Docket Number:	09-AFC-05C
Project Title:	Abengoa Mojave Compliance
TN #:	231771
Document Title:	STATEMENT OF STAFF APPROVAL OF PROPOSED CHANGE
Description:	PROPOSED CHANGE
Filer:	Raquel Rodriguez
Organization:	California Energy Commission
Submitter Role:	Commission Staff
Submission Date:	1/28/2020 11:05:14 AM
Docketed Date:	1/28/2020

STATEMENT OF STAFF APPROVAL OF PROPOSED CHANGE MOJAVE SOLAR PROJECT (09-AFC-05C)

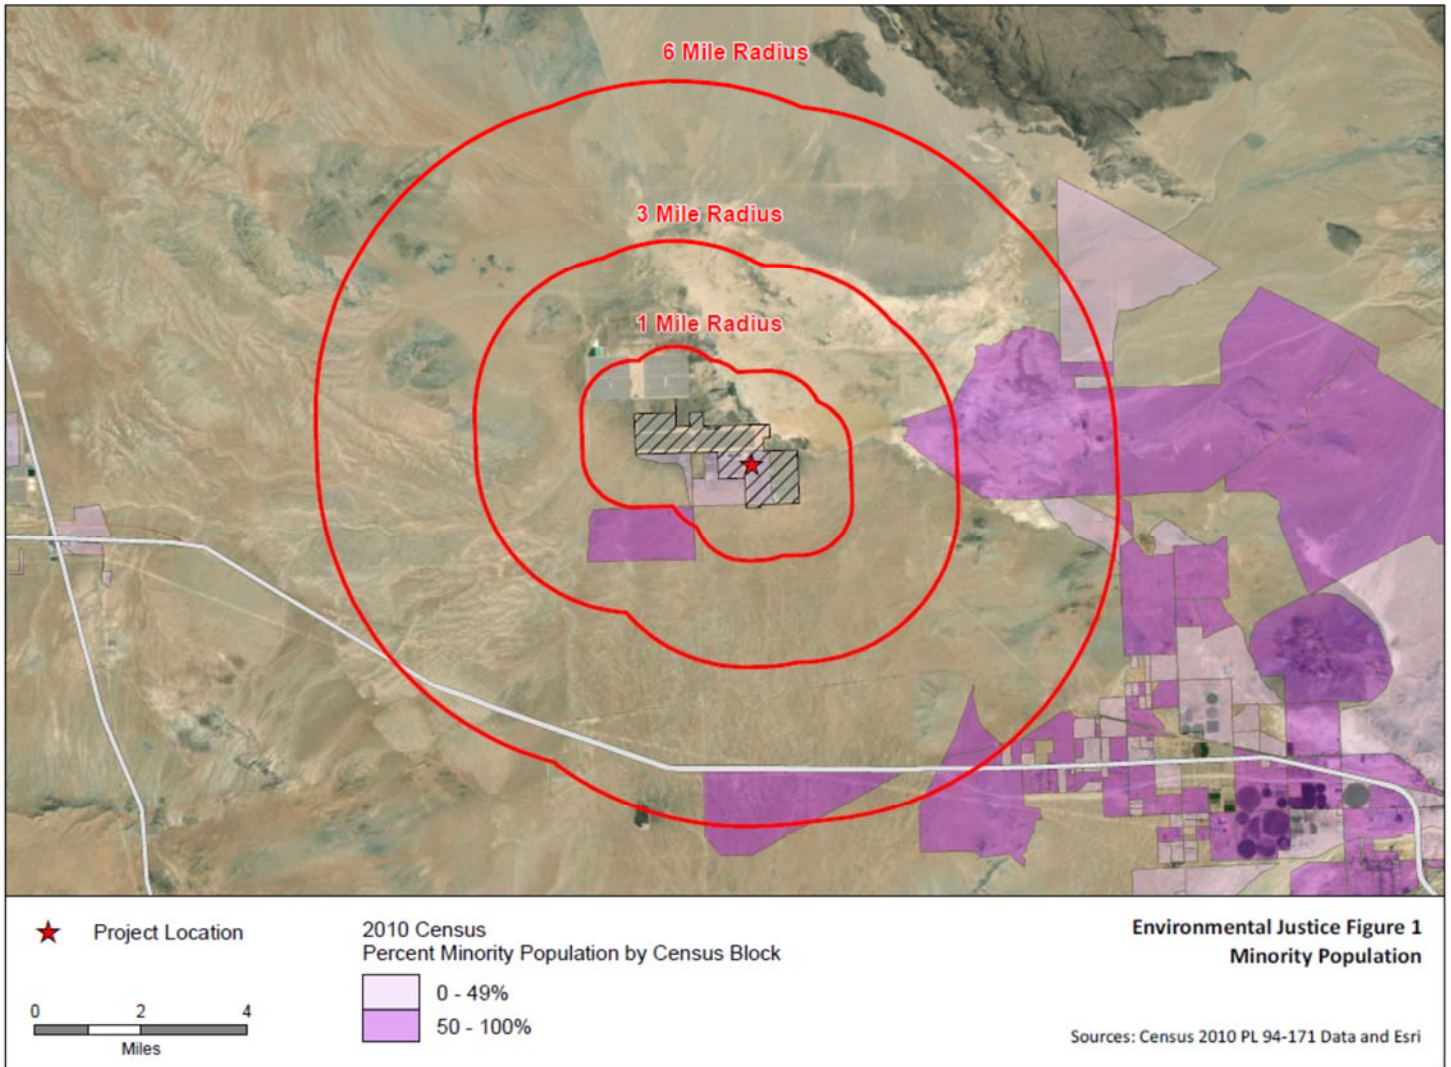
Environmental Justice – Figure 1 shows 2010 census blocks in the six-mile radius of the Mojave Solar Project with a minority population greater than or equal to 50 percent. The population in these census blocks represents an environmental justice (EJ) population based on race and ethnicity as defined in the United States Environmental Protection Agency's *Guidance on Considering Environmental Justice during the Development of Regulatory Actions*. Staff obtains demographic data within a six-mile radius around a project site based conservatively on the parameters for dispersion modeling used in staff's air quality analysis. Air quality impacts are generally the type of project impacts that extend the furthest from a project site. Beyond a six-mile radius, air emissions have either settled out of the air column or mixed with surrounding air to the extent the potential impacts are less than significant. The area of potential impacts would not extend this far from the project site for most other technical areas included in staff's EJ analysis.

For the technical areas affected by the project modifications – Hazardous Materials Management, Traffic and Transportation, and Visual Resources – staff concludes that impacts would be less than significant, and thus would be less than significant on the EJ population represented in **Environmental Justice – Figure 1, Figure 2, and Table 1.**

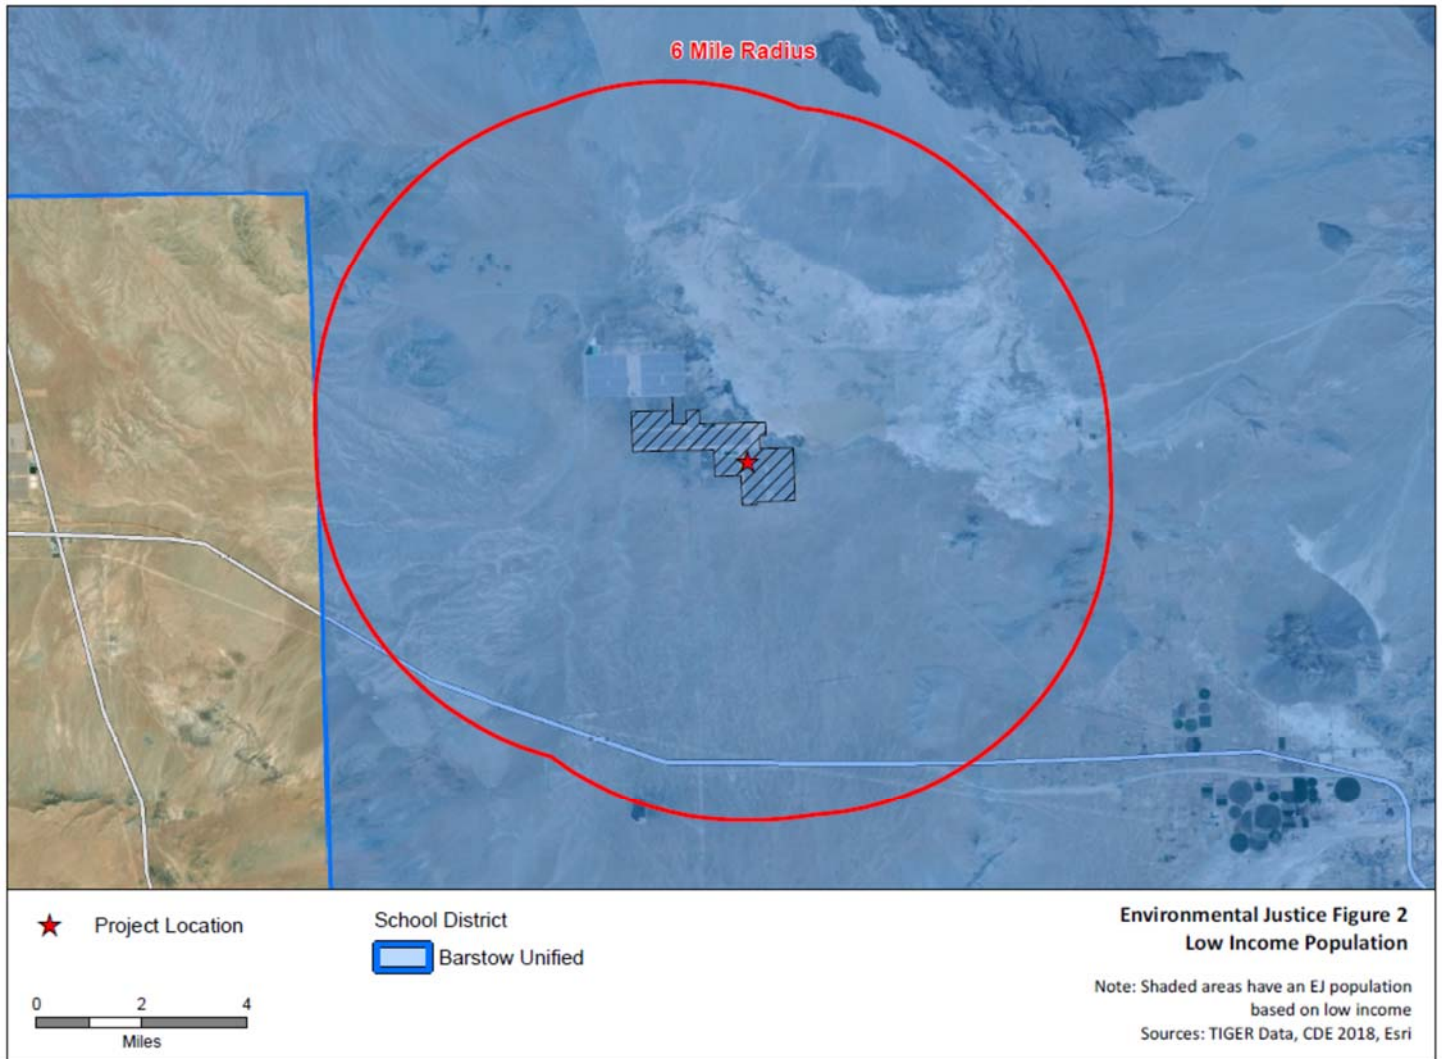
Environmental Justice – Figure 2 shows where the boundaries of the school district are in relation to the six-mile radius around the Mojave Solar Project site.
